Town of Boxborough, Massachusetts
Planning Department
Staff Report – Site Plan Approval & Special Permit

January 20, 2017

Site: 700, 750, & 800 Massachusetts Avenue

SITE PLAN IN BOXBOROUGH, MASSACHUSETTS MASTER PLAN

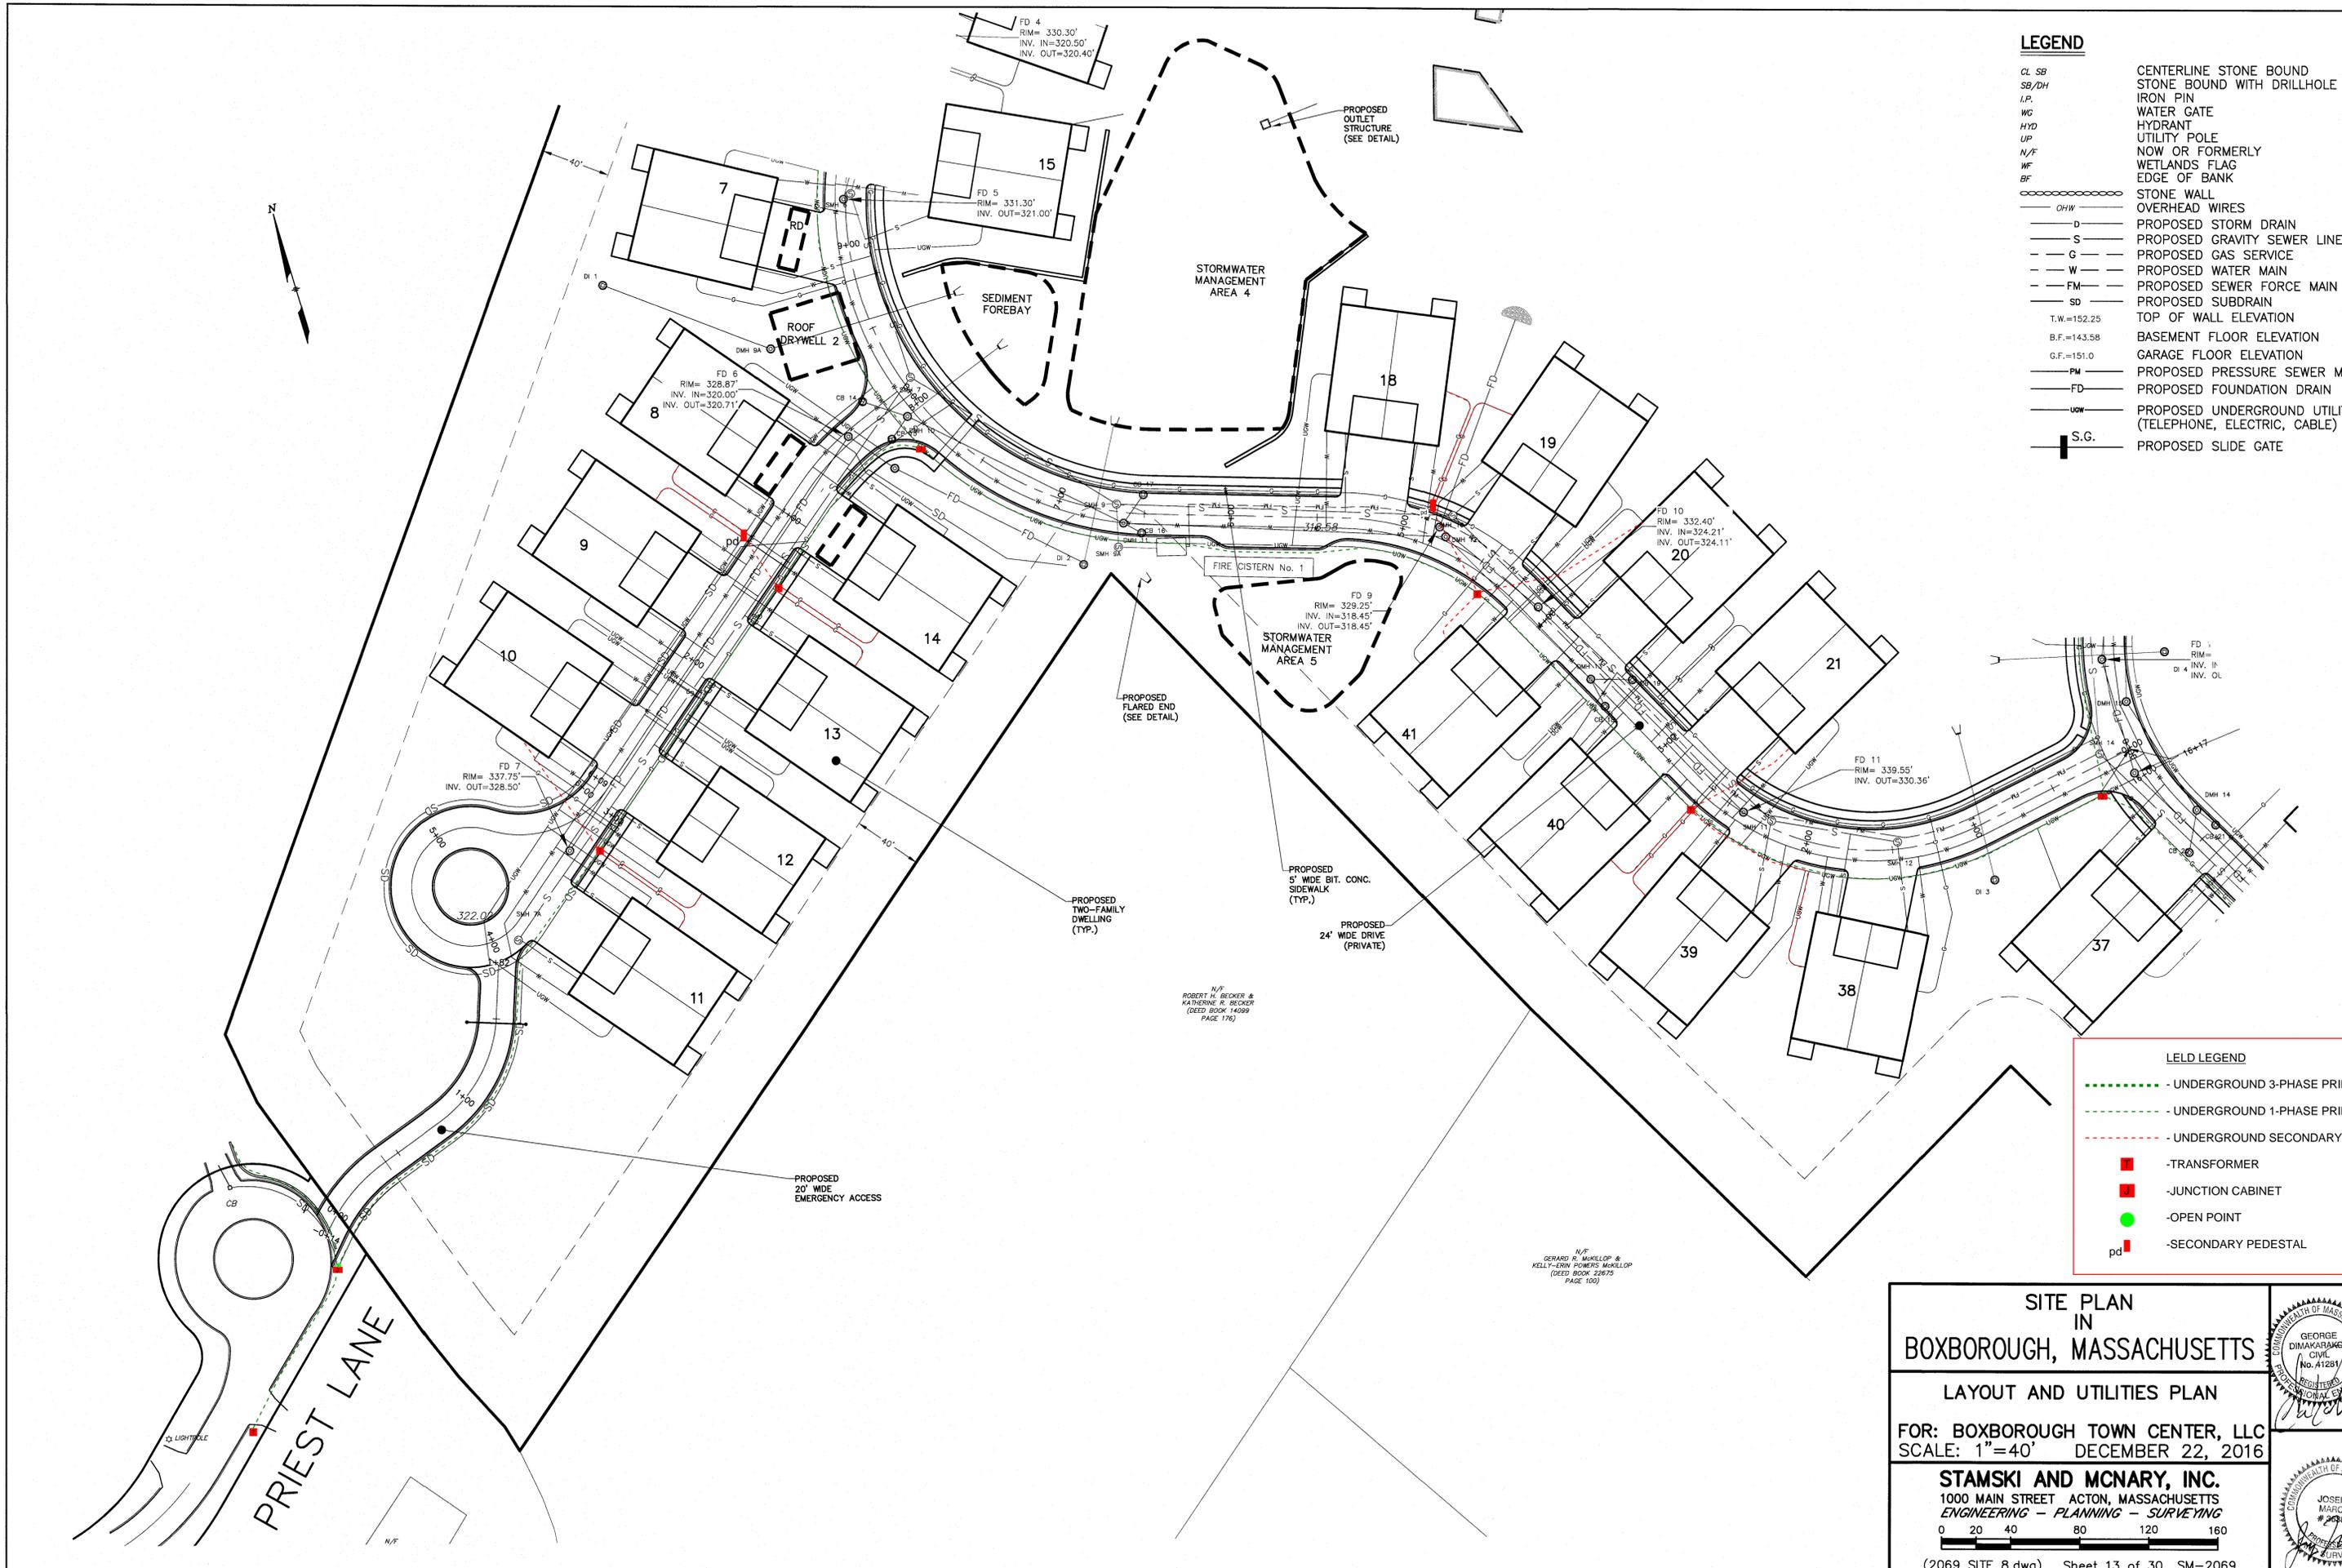
Littleton Electric Light Department (LELD): In two emails to the Town Planner on January 17, 2017, LELD indicated the following (please see the attached drawings for the proposed transformer locations):

“Please see the attached drawings of LELD’s proposed design. Please note that this is only a preliminary design and may change before the site work begins. Also, in a few locations throughout the development LELD is requesting that the gas service flips to the opposite side of the proposed underground electrical secondary locations. Those locations are shown on the drawing.

We also will need to reconstruct the Sheriff’s Meadow Condo entry off of Stow Rd. so that we can bring three-phase power to the wastewater treatment facility. This design is not shown on the drawings.
